WESTERN ENERGY COMPANY ROSEBUD MINE Area D

Type of Statement: Final Environmental Impact Statement

WESTERN ENERGY COMPANY'S
ROSEBUD MINE
AREA D

OSM-EIS-10

FIGURE II-4 (revised page II-9)

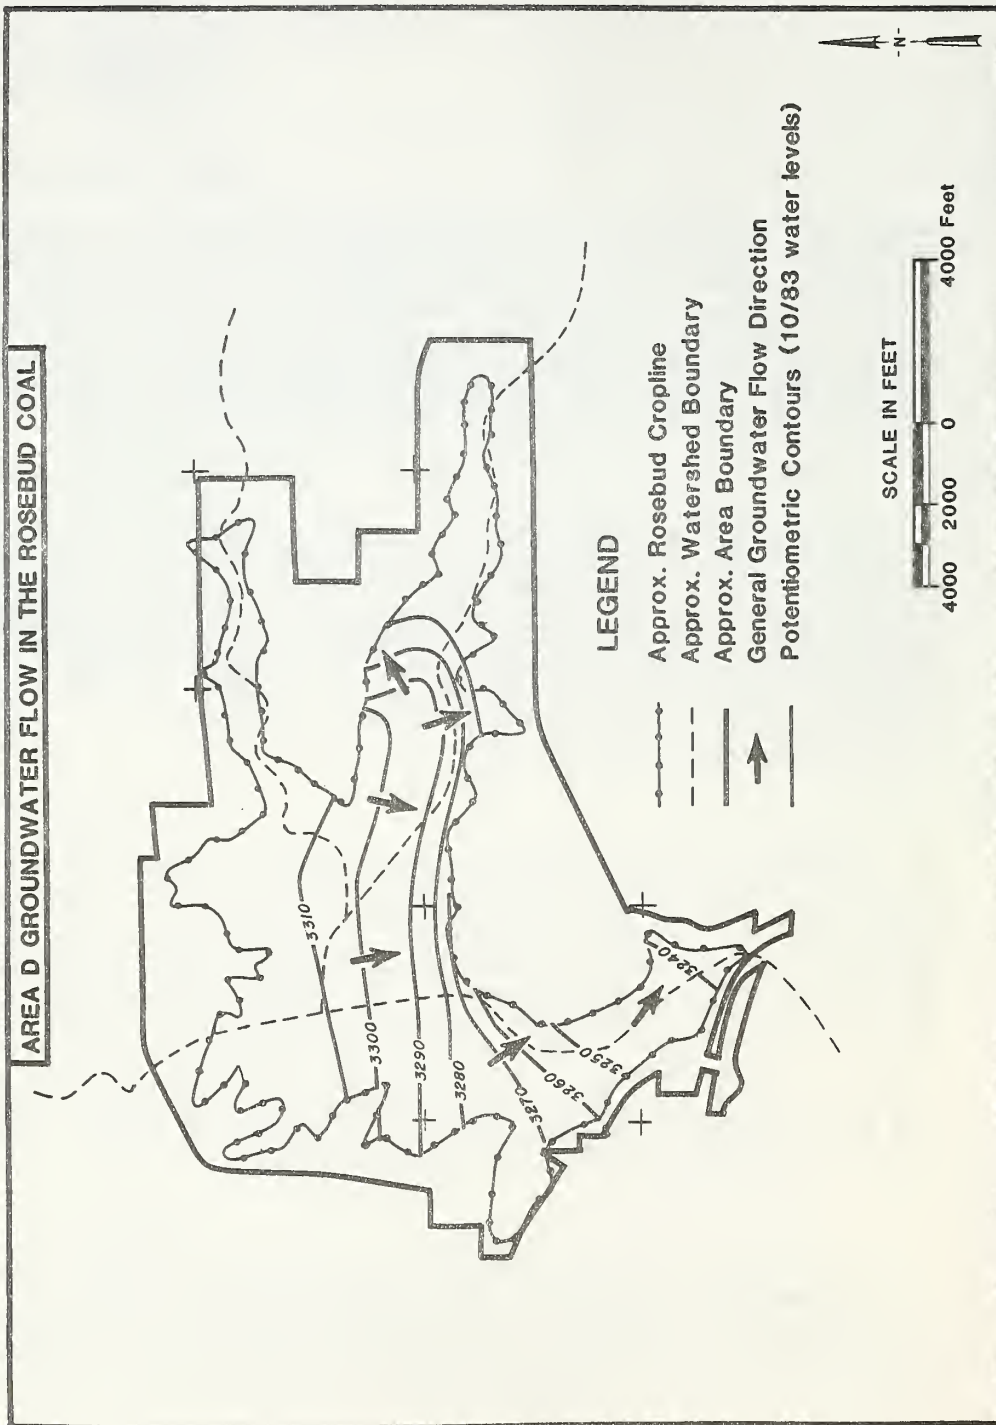
- B 2. Figure II-4 - If the potentiometric contours shown on figure II-4 are for the Rosebud coal as implied in the title, the lines should terminate at the approximate Rosebud cropline.

- B You are correct; the figure has been corrected.
- C The inflow of 35-80 gpm will probably be distributed along the entire mine pit and should not present a problem. If it presents an operational problem it will be collected in pumps and pumped to sedimentation ponds prior to discharge (see revised text).
